REMARKS

Amendments to the Drawings:

FIG. 3

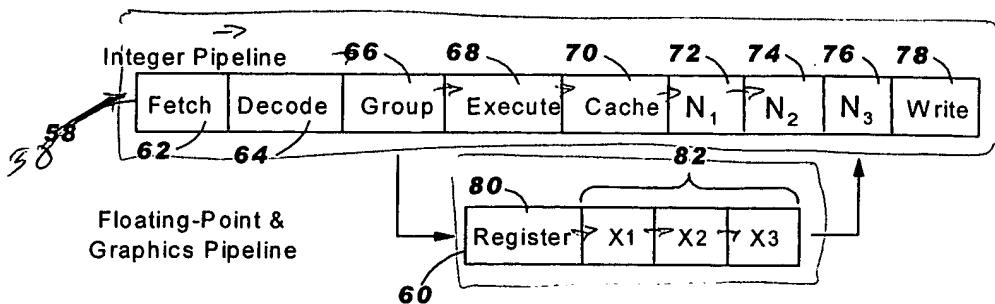
The Examiner has rejected the drawings for failing to particularly point out all of the features described in the claims. Applicant respectfully submits an amended set of drawings which serve to identify each feature claimed within the pending application. Applicant additionally requests the cancellation of Figure 4 from the pending application. Applicant further submits that the features of claims 5, 6, 7, 8, 12 and 13 are depicted clearly in currently pending figures 6A and 6B. Applicant additionally submits that the compression of instructions in accordance with claims 12 and 13 is further depicted in pending figures 8A and 8B. In regards to elements disclosed in claims 14 – 17, Applicant submits that the Figures 7, 8A, and 8B details these elements in accordance with 37 CFR 1.83(a). In light of the newly submitted drawings, Applicant respectfully requests that the Examiner withdraw the rejection to the drawings.

In particular, Figure 3 has been amended to more clearly illustrate the passage of an instruction through an instruction pipeline. Additionally, Figure 6A and 6B have been amended to illustrate the use of an edge detection circuit 91 with the present invention.
